United States Patent and Trademark Office

| APPLICATION NO. | FILING DATE | FIRST NAMED INVENTOR | ATTORNEY DOCKET NO. | CONFIRMATION NO. |
|---------------------------|-----------------------|----------------------|---------------------|------------------|
| 10/773,657 | 02/06/2004 | Fritz Leber | ZAHFRI P590US | 7612 |

DETAILED ACTION

The following Office Action is responsive to the amendment filed June 21, 2005.

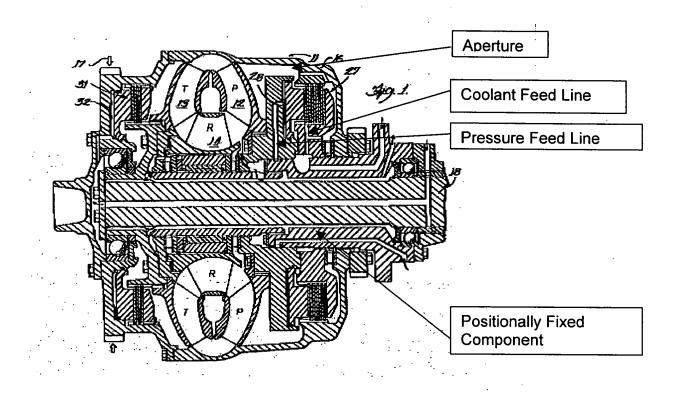
Allen et al. discloses a hydrodynamic torque converter (Fig. 1) comprising a clutch (27), a drive/housing (16), a pump impeller wheel (12), a turbine rotor (13), a controllable actuation device (28), an aperture (Fig. 1), a positionally fixed component

(Fig. 1) with a rotary connection, a pressure feed line (Fig. 1), and a coolant feed line (Fig. 1). Allen et al. does not show a pressure sensor.

However, the practice of using sensors for controlling torque converter clutches and/or clutches in general is very common in the art. For example, Suzuki discloses a torque converter (Fig. 1) comprising a stationary internal pressure sensor (Col. 9, lines 14-26), a pressure lines (15, 16), a tapping point, and a control unit (31). Then, it would have been obvious to a person of ordinary skill in the art at the time the invention was made to provide a pressure sensor in the device of Allen et al. in view of Suzuki to monitor the operating conditions within the torque converter.
